Annex 93A Package/Die Load Proposal and COM 3.70 with Exploratory Features including Package/Die Load Ladder

Richard Mellitz, Samtec

March 16, 2022

Figure 93A–2—Reference package model

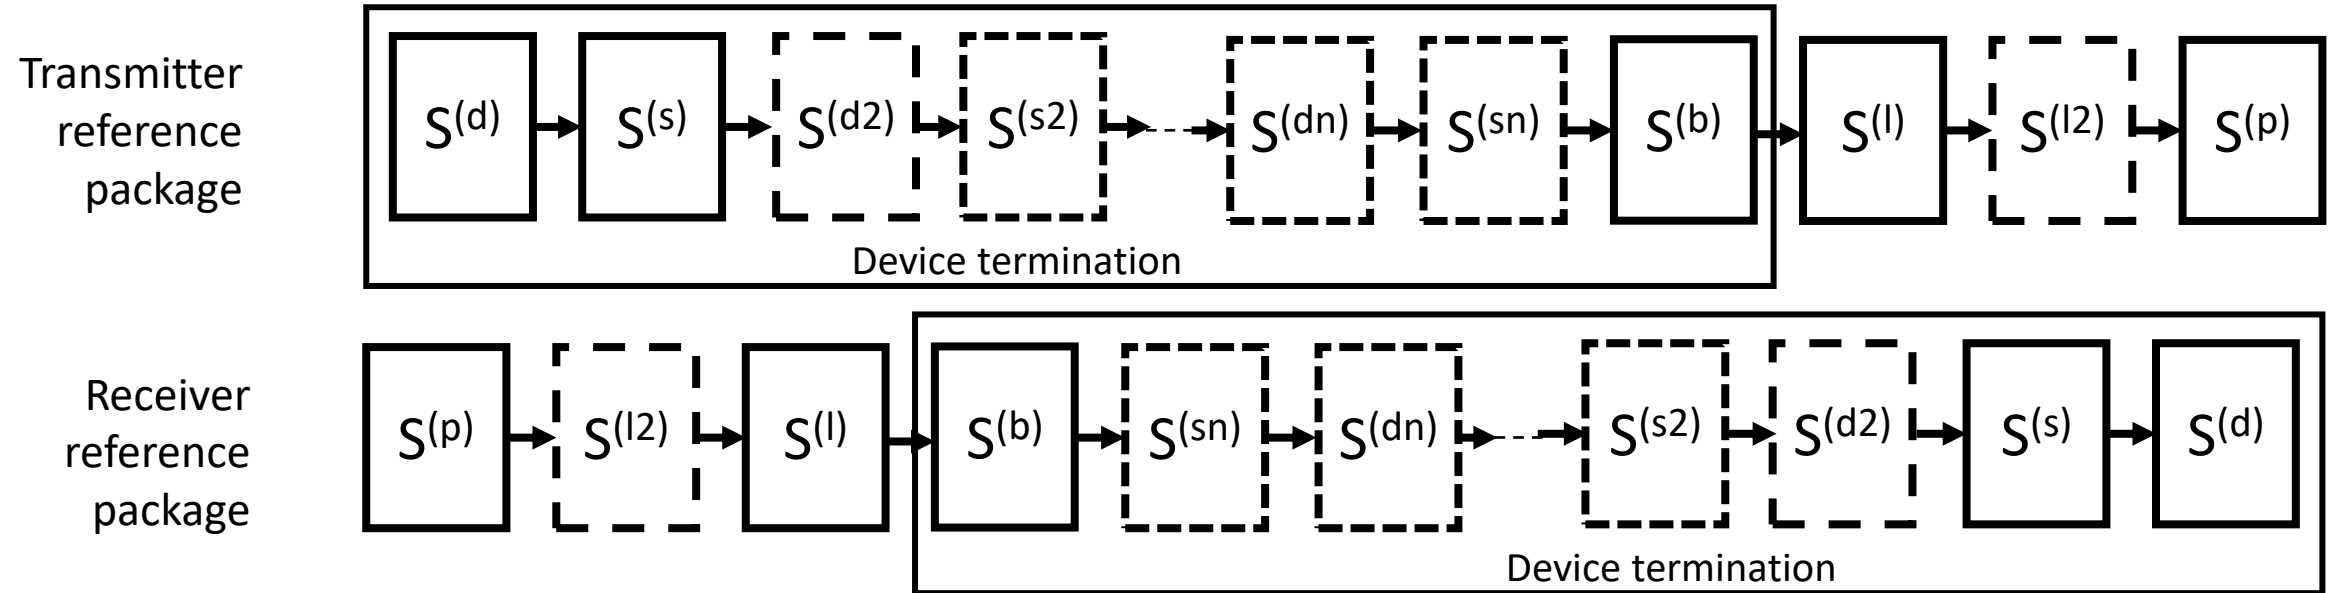
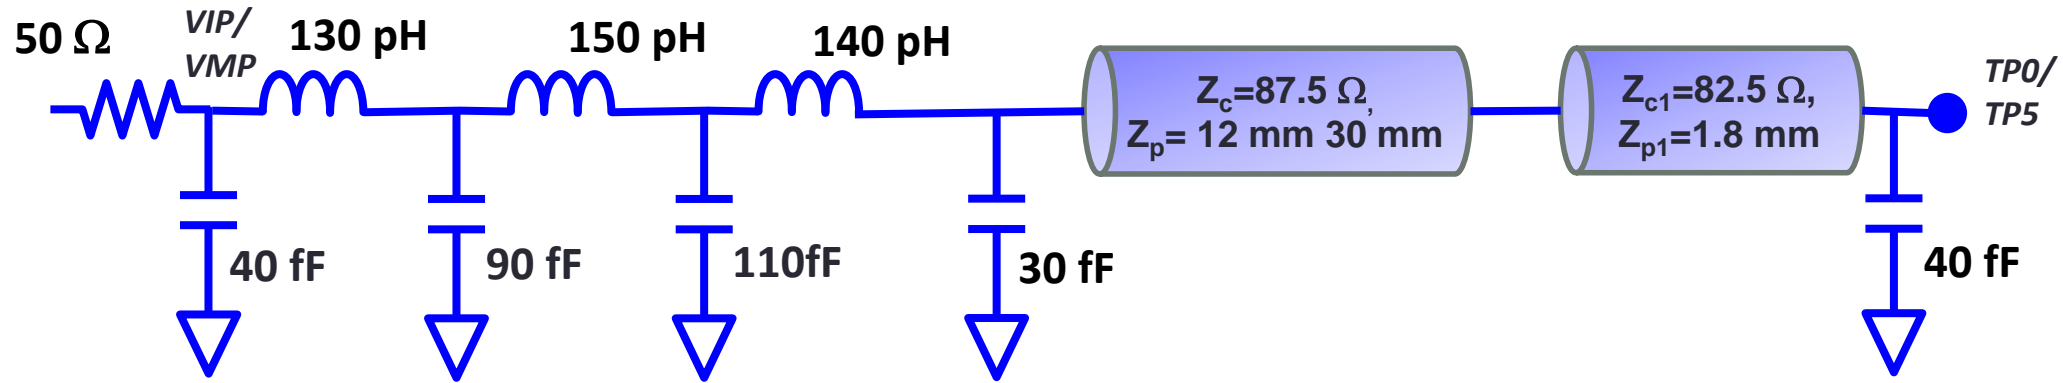
Replace Cd and Ls with a Ladder

C_d	[$C_d C_{d2} C_{d3} C_{d4} \dots C_{dn}$; $C_d C_{d2} C_{d3} C_{d4} \dots C_{dn}$]	nF	[TX ; RX]
L_s	[$L_s L_{s2} L_{s3} L_{s4} \dots L_{sn}$; $L_s L_{s2} L_{s3} L_{s4} \dots L_{sn}$]	nH	[TX ; RX]

Proposal

Note: PMD calls out which blocks are included in the package model

C_d	[0.4e-4 0.9e-4 1.1e-4 ; 0.4e-4 0.9e-4 1.1e-4]	nF	[TX RX]
L_s	[0.13 0.15 0.14; 0.13 .15 0.14]	nH	[TX RX]
C_b	[0.3e-4 0.3e-4]	nF	[TX RX]
z_p select	[1 2 3 4]		[test cases to run]
z_p (TX)	[12 31; 1.8 1.8]	mm	[test cases]
z_p (NEXT)	[12 29; 1.8 1.8]	mm	[test cases]
z_p (FEXT)	[12 31; 1.8 1.8]	mm	[test cases]
z_p (RX)	[12 29; 1.8 1.8]	mm	[test cases]
C_p	[0.4e-4 0.4e-4]	nF	[TX RX]
R_0	50	Ohm

Initially parameters and number of element should be TBD for the baseline

C2M like COM Comparison for 14 dB (@ 53.25 GHz) Channel

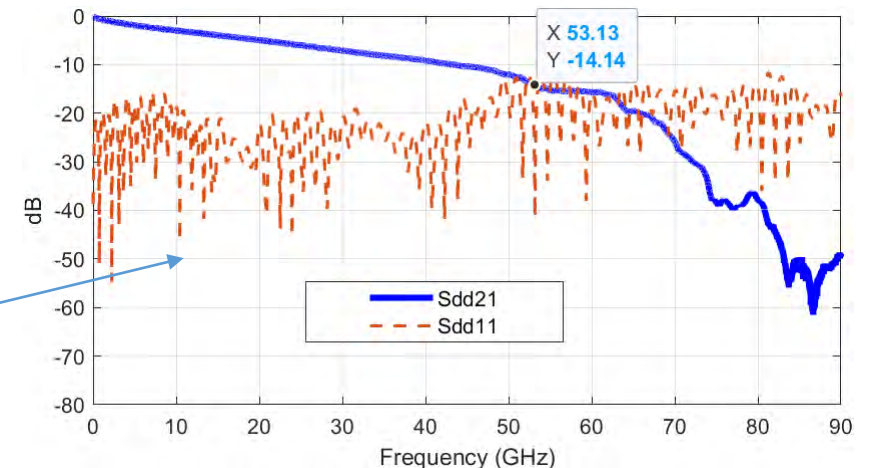
A .3ck model with $c_d=70$ fF, $L_s=100$ pH, and $C_b=23$ fF has about the same VEC, EH, and COM for the ladder model above. A 70 fF die load seems quite small. More work need here.
